**LEBANON PLANNING BOARD
JULY 12, 2021 - 6:30 PM
COUNCIL CHAMBERS, CITY HALL OR
REMOTE VIA VIRTUAL PLATFORM
LEBANONNH.GOV/LIVE**

Mason Storage, LLC, 38 Spencer
Street (Tax Map 78, Lot 39), zoned
LD
PB2021-13-SPR

Staff Memorandum – PB2021-13-SPR – *postponed from 6/7/21*

St. Johnsbury Automobile Group (applicant) and ORQT, LLC (property owner), 425 Miracle Mile (Tax Map 103, Lot 15), zoned GC: Request for Site Plan Review to expand the existing building with the construction of +/-12,900 sq. ft. of additional building area to accommodate a showroom and additional vehicle service bays, together with associated site improvements including utilities, lighting, landscaping, stormwater management, parking, and access. PB2021-19-SPR

LANDSCAPE PLAN
Prepared for:
Labanon Ford New Addition

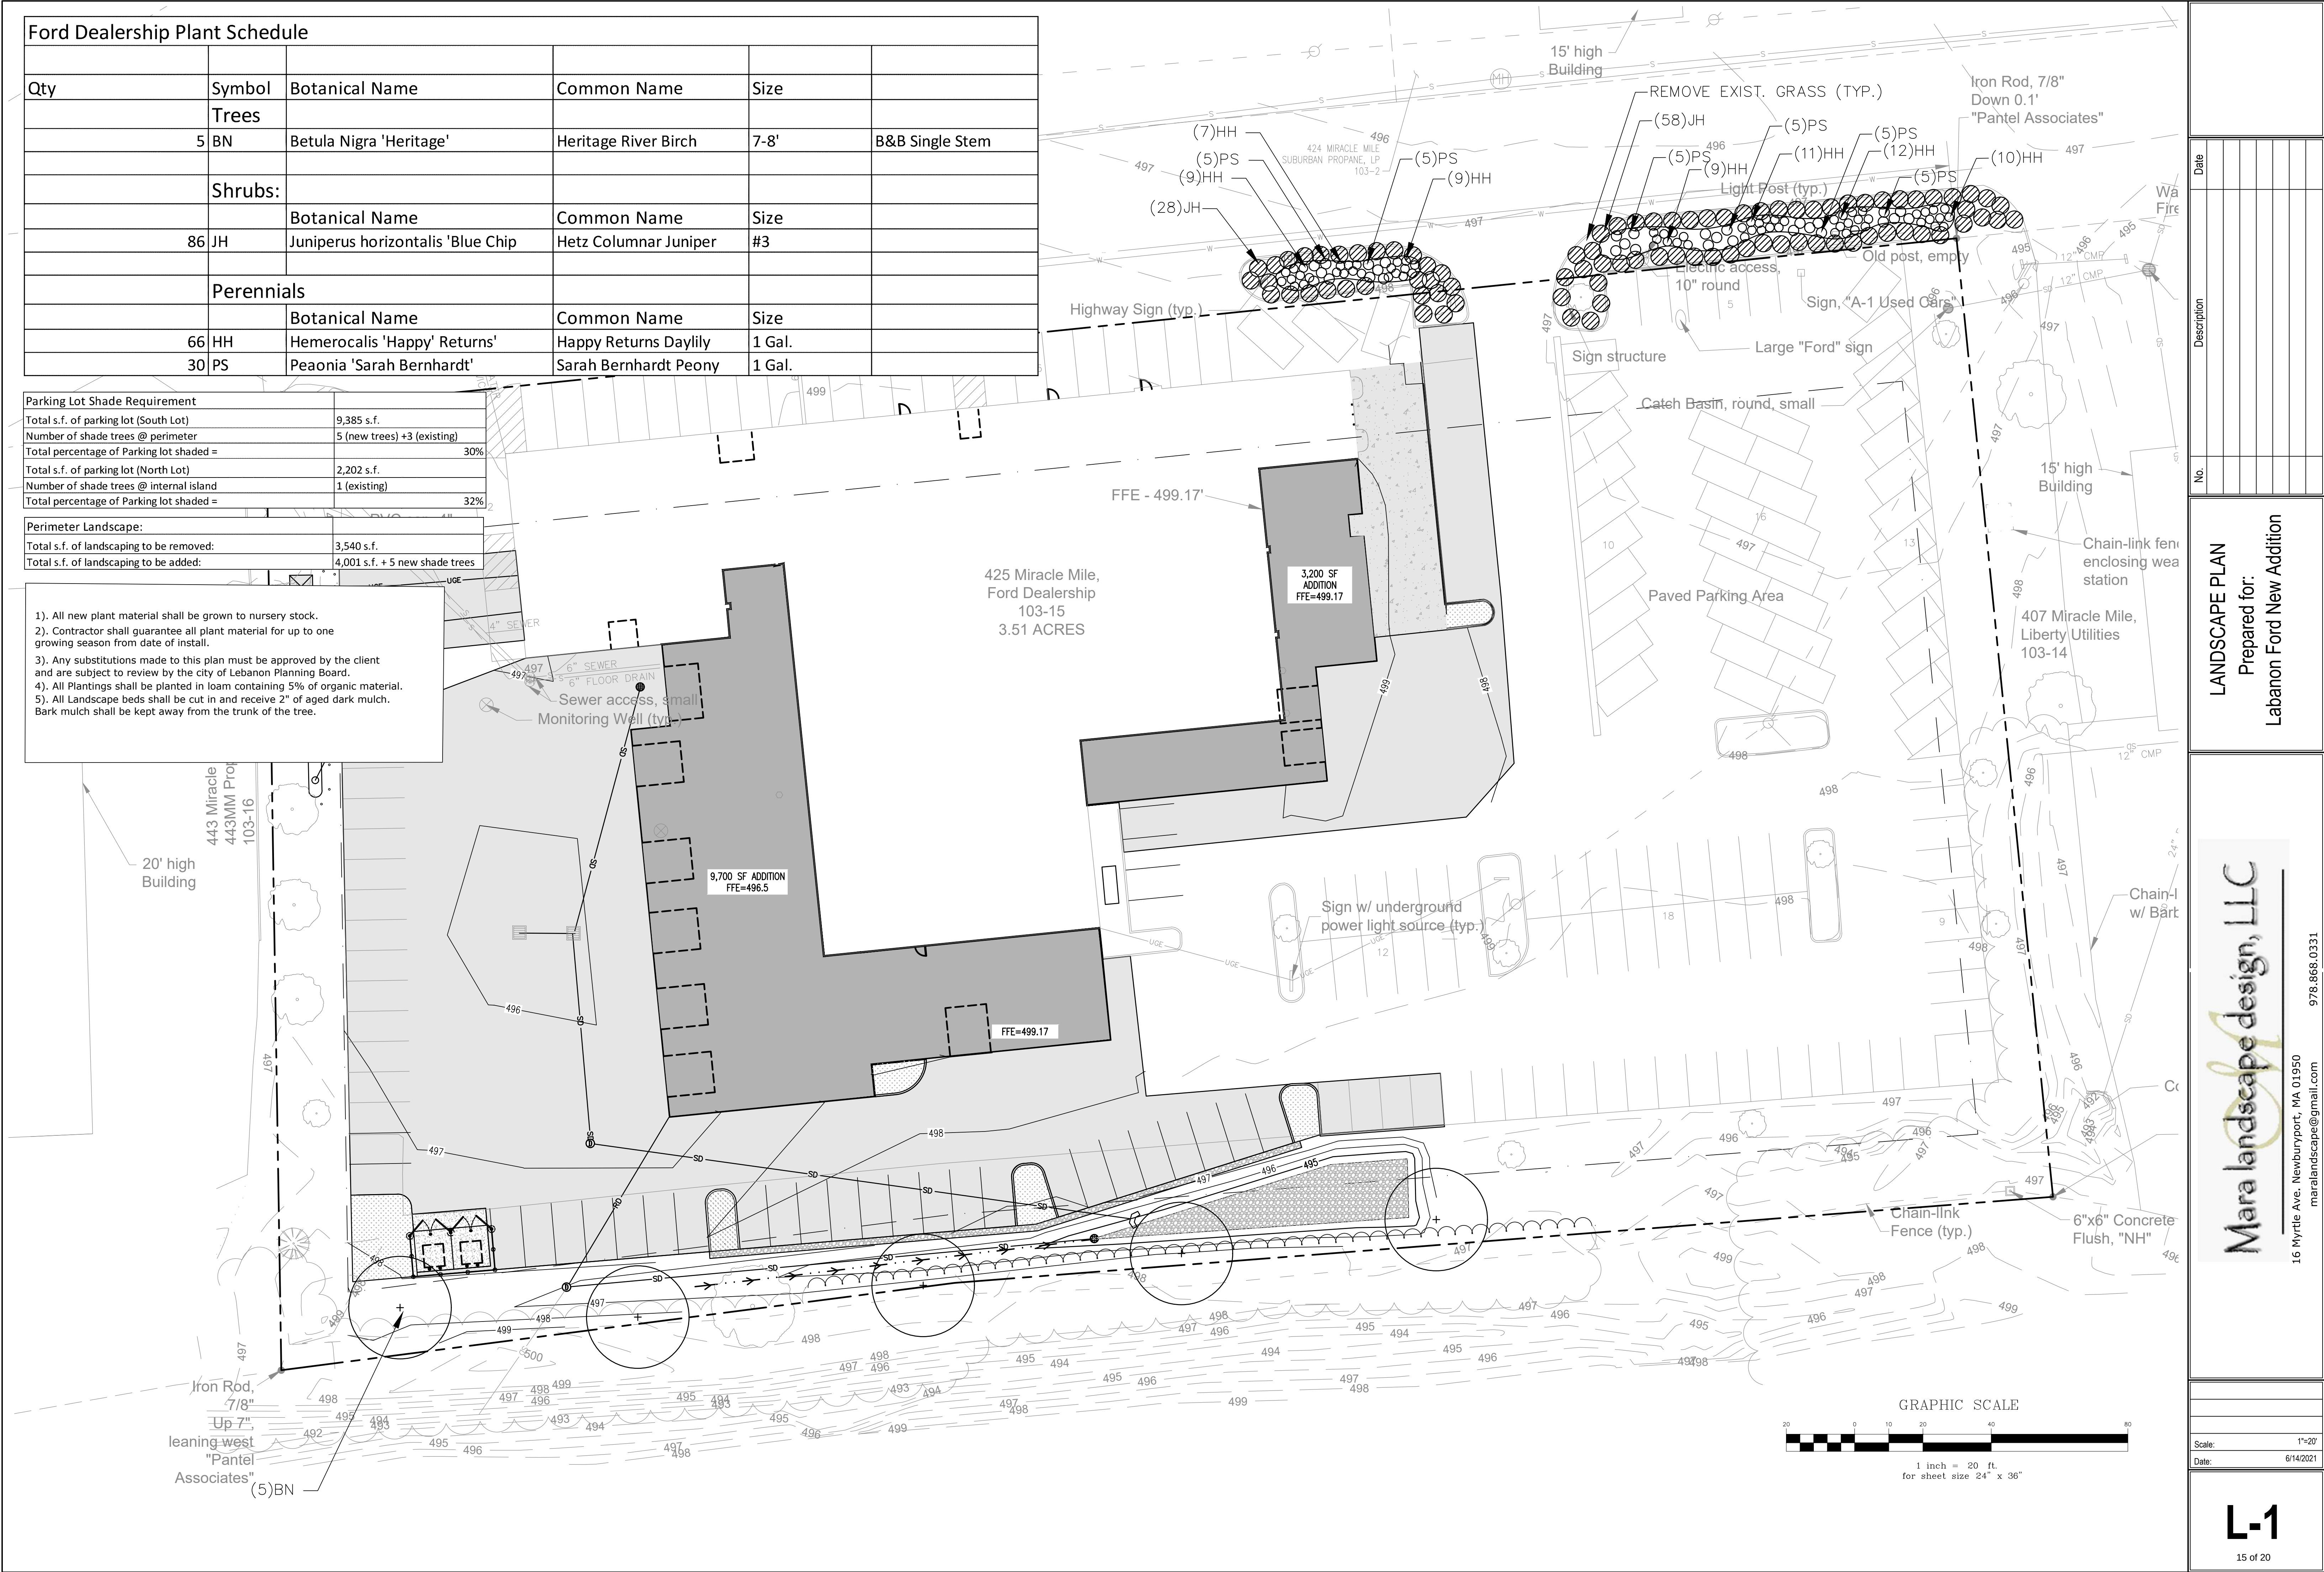
25. The plat is very difficult to read. To make less confusing and more readable, please remove unnecessary layers including existing conditions. The unnecessary layers and information have been removed from the landscape plan
26. Staff recommends that additional landscaping improvements are provided in order to bring the property more into conformance with the Section 6.2.B, D, and E landscaping design requirements.
27. Indicate how the dumpster will be screened as required by Section 6.2.B.8, and provide details. The dumpster screen detail has been added to sheet C3.2 The dumpster screen detail has been added to plan sheet C3.2, please see detail 5 on this sheet.
28. On the "Plant Schedule" table:

- a. What does the “B&B Single Stem” notation mean? **Balled and burlapped**
 - b. What does the “#3” in the size column mean? **3 gallon container**
 - c. Is “1 gallon” the correct size for the perennials? **yes**
29. Please add notes relative to the planting and seeding of disturbed areas. **Please see detail 3 on sheet C3.3 for this information**
30. Please add the following sections of the Site Plan Review Regulations as plan notes:
- a. 6.2.B.3 (“All new plant material shall be nursery-grown stock.”)
 - b. 6.2.B.4 (just the first sentence)
 - c. 6.2.B.5
 - d. 6.2.F.1
 - e. 6.2.F.2
 - f. 6.2.H.1
 - g. 6.2.J
 - h. 6.2.K

The above landscape notes have been added to sheet C0.1 Legends and Notes
